AP 113D-0721-2

# CONTROL PANEL TYPE 12 LUCAS AEROSPACE TYPE F2801

## GENERAL ORDERS AND MODIFICATIONS

Mod No LG2257 Rev 1 (Class C/3) on replacement

# FIGURE 1

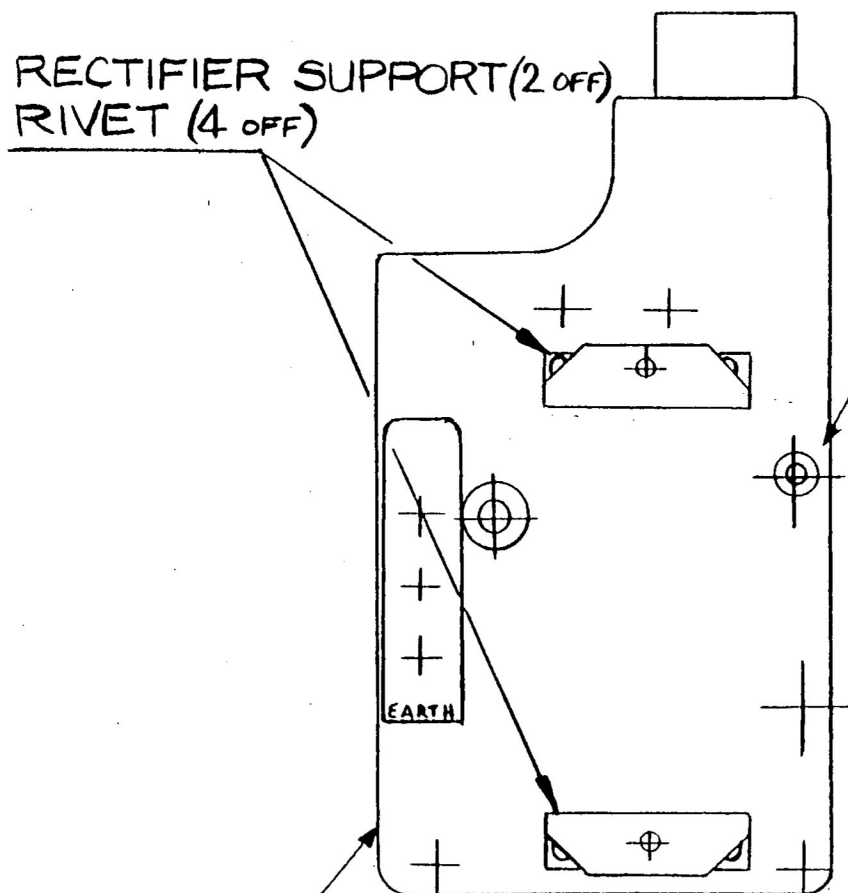
- (1) Remove mounting plate assembly N45465.
- (2) Remove terminal block N64112, rectifier N45583, rectifier N45583-1 and their associated fixing components. Discard rectifiers and nuts NK10009L.
- (3) Remove and discard 2 rectifier supports N45455 and 4 rivets NK18206M.
- (4) Remove and discard screw NL519L from the position marked reference drawing no LG2257 Rev 1 Fig 1.
- (5) Countersink the hole to 0.218"/0.228" diameter x 90° in the position shown in Fig 1.
- (6) Protect the machined surface using Alocrom 1200 (33C/1835).

- (7) Assemble 2 new rectifier supports 80229223 and secure using 4 rivets NK18206M.
- (8) Assemble screw NK3817L in the position marked reference Fig 1.
- (9) Assemble new Rectifier 80229156, Rectifier 80229160, 4 off Nuts 91412134, the retained fixing components and new Insulation 80229159 in the position as shown in Fig 2.
- (10) Re-assemble the control panel as stated in AP113D-0721-16.

REMOVE AND DISCARD SCREW NL519L  
COUNTERSINK EXISTING HOLE TO  
0.218"/0.228" DIA. x 90° FROM THIS SIDE.
